STATE OF MAINE
DEPARTMENT OF TRANSPORTATION
16 STATE HOUSE STATION
AUGUSTA, MAINE
04333-0016

January 29, 2010
Subject: **Brewer**
Federal Project No: HP-1487(110)X
State Pin No: 014871.10
Amendment No. 1

PIN 14871.10 - BREWER
RESET CONCRETE PAVERS
608(261)

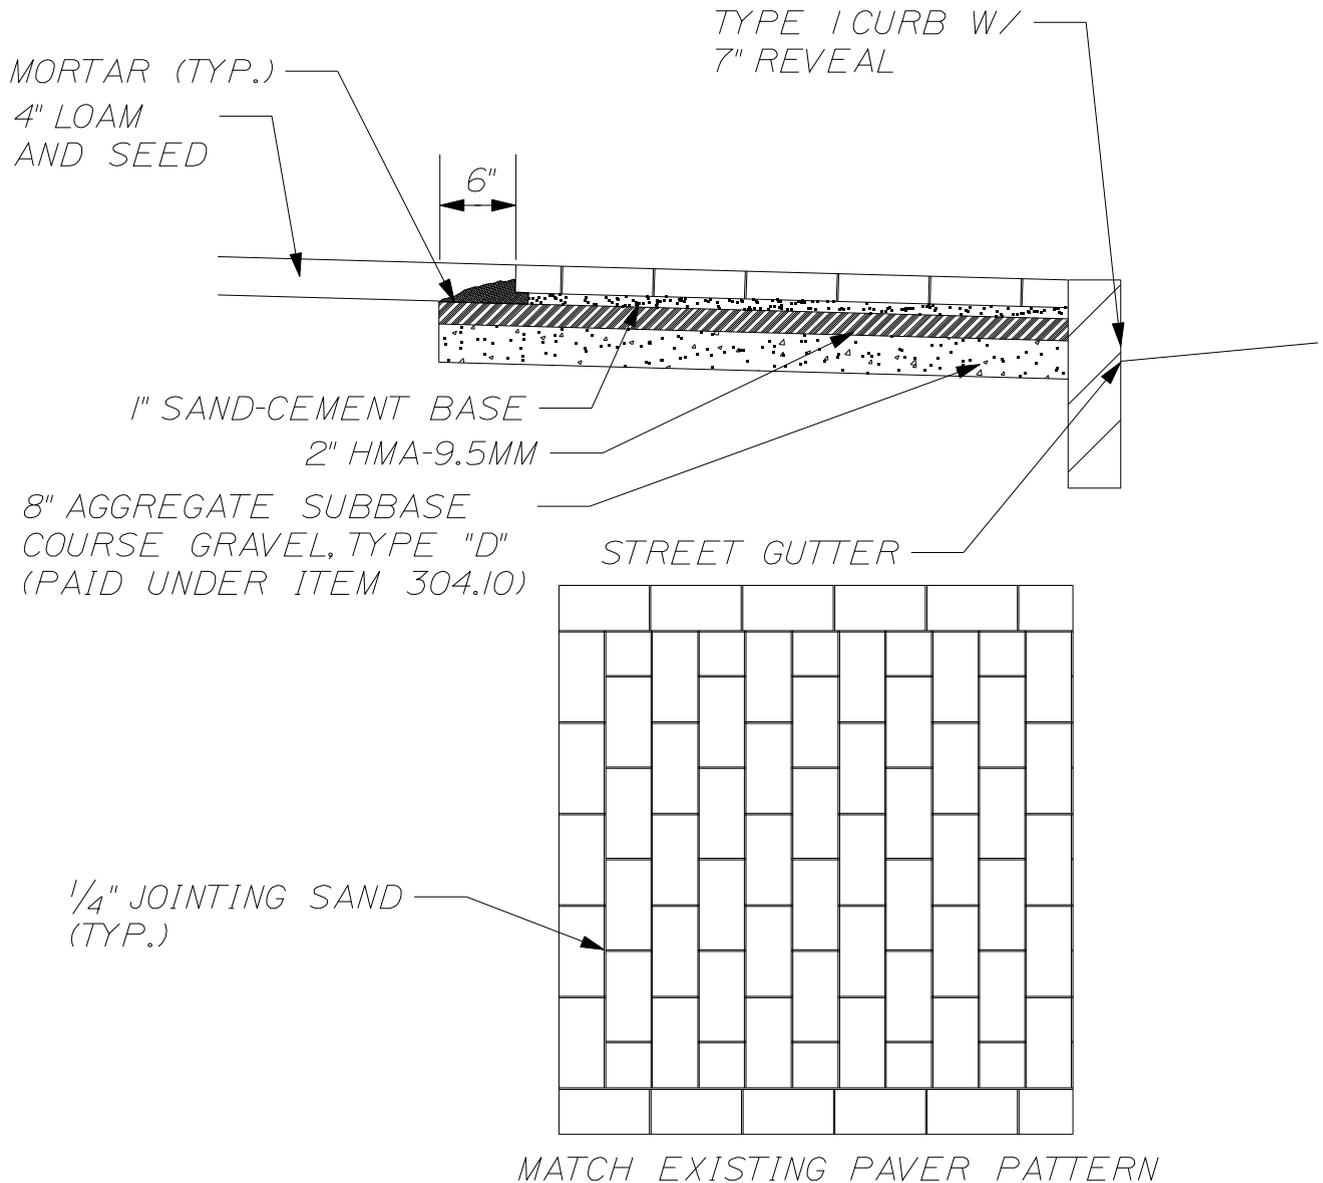
In the Bid Book, after page 78, **ADD** the attached "RESET CONCRETE PAVERS" detail, 1 page dated 1/27/2010.

Question: Could you please provide a detail for item 608.261, Reset Concrete Pavers?

Response: Refer to "Reset Concrete Pavers" detail added in this amendment.

1. PAY ITEM 608.261 SHALL INCLUDE RESET CONCRETE PAVERS, MORTAR, SAND CEMENT BASE, AND 2" HMA.
